Access Compliance Report

Public Rights-of-Way

Intersection ID: 28390	Main Street: ARDREY_KELL_RD	Cross Street: BRIDGEHAMPTON_CLUB_DR	Location: E
ADA ID: D52D83DC9C68	Ramp Type: BlendTrans1	Initial Pass/Fail: Fail	Overall Compliance: No
			Severity Score: 33.75

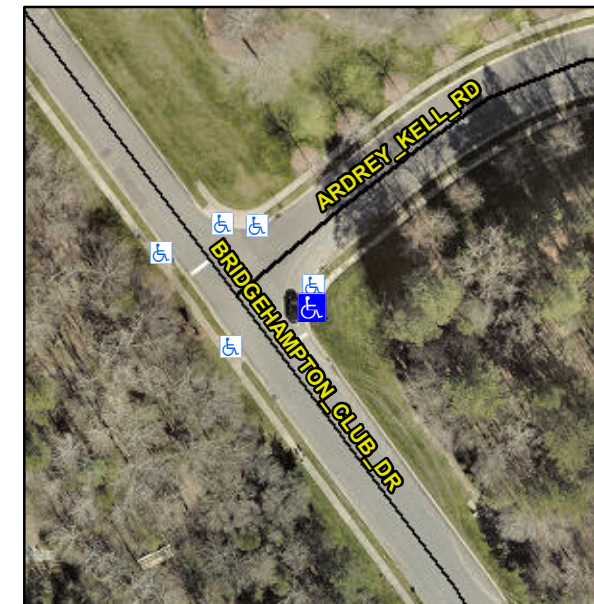
Not Found, R304.5.1, R304.5.3

Compliance	Description	Data	Compliance	Description	Data
N/A	Ramp Length (in)	47.5	Yes	BlendTrans Slope (%)	3.0
No	Ramp Width (in)	40.0	No	BlendTrans XSlope (%)	7.4
N/A	Flare Type LT	N/A	N/A	Flare Type RT	N/A
N/A	Flare Slope LT (%)	N/A	N/A	Flare Slope RT (%)	N/A
N/A	Flare Traversable LT?	N/A	N/A	Flare Traversable RT?	N/A
N/A	Landing Length (in)	N/A	N/A	DWS Provided?	N/A
N/A	Landing Width (in)	N/A	N/A	DWS Contrast?	N/A
N/A	Landing Slope (%)	N/A	N/A	DWS Length (in)	N/A
N/A	Landing X Slope (%)	N/A	N/A	DWS Full Width?	N/A
N/A	Landing Curb? (Y/N)	N/A	N/A	DWS Offset (in)	N/A
N/A	Shared Landing?	N/A			
N/A	Gutter Ponding?	N/A	N/A	Gutter Slope (%)	N/A
N/A	Gutter Lip Ht (in)	N/A	N/A	Gutter X Slope (%)	N/A
N/A	Painted X Walk1?	No	N/A	Painted X Walk2?	N/A
	X Walk 1 Direction	To SW		X Walk 2 Direction	N/A
	X Walk 1 Width (in)	N/A		X Walk 2 Width (in)	N/A
	X Walk 1 Slope (%)	3.3		X Walk 2 Slope (%)	N/A
	X Walk 1 X Slope (%)	3.3		X Walk 2 X Slope (%)	N/A

N/A	Ramp inside XWalk1?	N/A	N/A	Ramp inside XWalk2?	N/A
	Road Slope (%)	3.3		Clear Space?	N/A
	Road X Slope (%)	3.3	N/A	Clear Space to XWalk (in)	N/A
N/A	Any Obstructions?	N/A	N/A	Storm Grate/Utility Hazard?	N/A
	Obstruction Type			Storm Grate/Utility Type	
		N/A			N/A
			Yes	Surface Condition? (G/P)	Good
			No	Curb Slope (%)	5.8

Remove & Replace Curb Ramp With Two New Directional Ramps or Equivalent.
